APPLICATION NO.	FILING DATE	FIRST NAMED INVENTOR	ATTORNEY DOCKET NO.	CONFIRMATION NO.
10/601,040	06/20/2003	Wayne Jacob Gregoire		7169

Office Action Summary

DETAILED ACTION

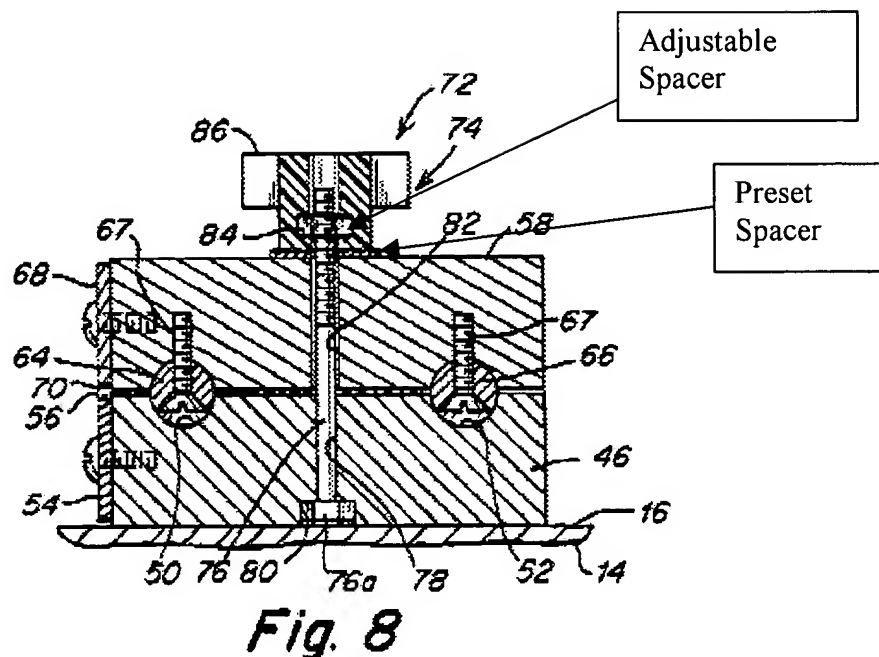
With regard to claim 15 as best as can be understood, Jukoff discloses an indexing channel extrusion (50, 52) an indexing block (44, 46), a guide attachment (68), an adjustable indexing component (70) an extruded forms means of adjustment and indexing. Examiner notes

that the teeth (70) of the guide attachment (68) of the horizontal/guide (58) engage teeth (56) of the indexing track (44, 46) so as to position and adjust the horizontal/guide bar (58).
